RE: Case 12-F-0410 - Application of Cape Vincent Wind Power, LLC, for a Certificate of Environmental Compatibility and Public Need to Construct an Approximately 200-285 Megawatt Wind Electric Generating Facility in the Town of Cape Vincent, New York.

Please find attached hereto the comments of Staff of the Department of Public Service relating to the Preliminary Scoping Statement filed by Cape Vincent Wind Power, LLC on March 29, 2013.

Case 12-F-0410  
Cape Vincent Wind Farm  
Preliminary Scoping Statement  
Staff of the New York State Department of Public Service

Map #2: Thousand Islands - St. Lawrence Wine Trail Map

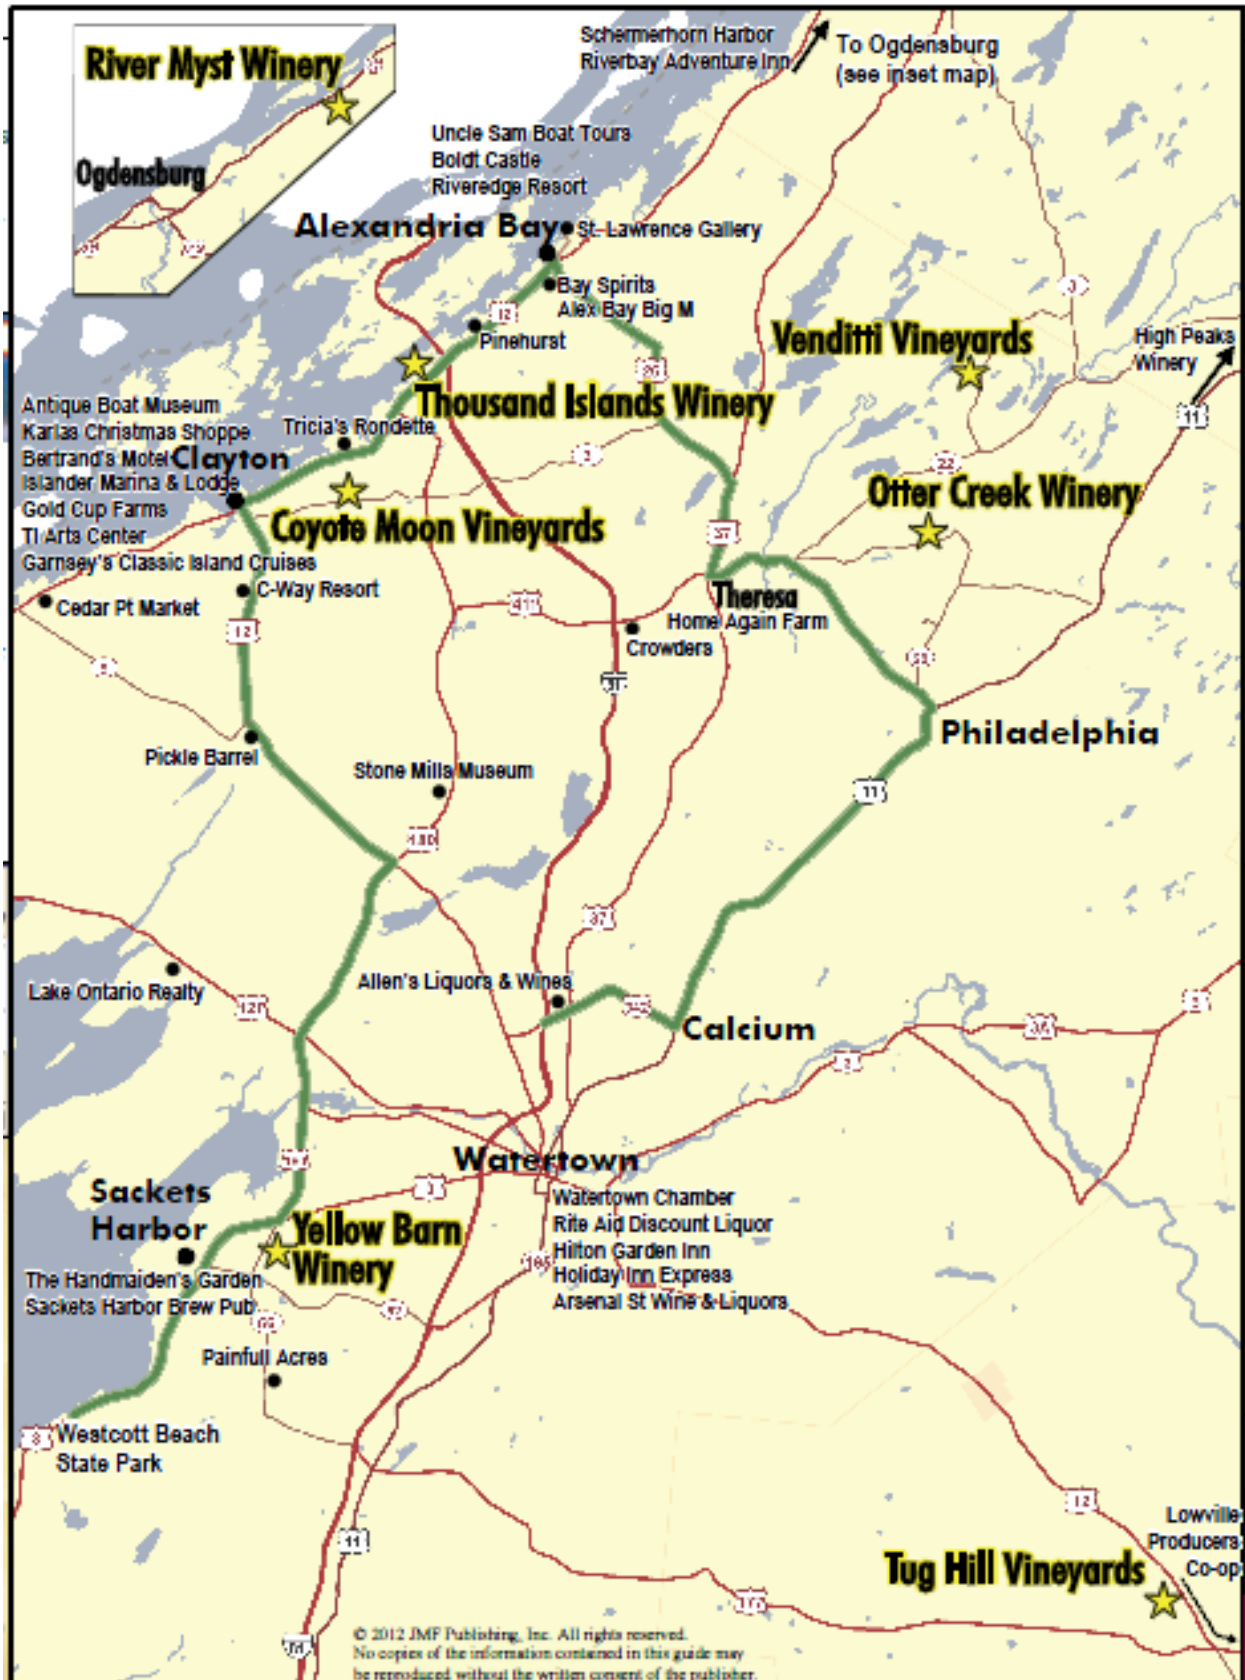
designated touring "trail" traverses along the easterly edge of the proposed CVWF Study Area as mapped at PSS Exhibit B. (A map of the "Wine Trail" is attached to these comments below as Map #2). This minor expansion of the Study Area will provide for an assessment of potential project visibility from a designated tourism route that is likely to have some areas with views of at least some of the proposed wind turbines.
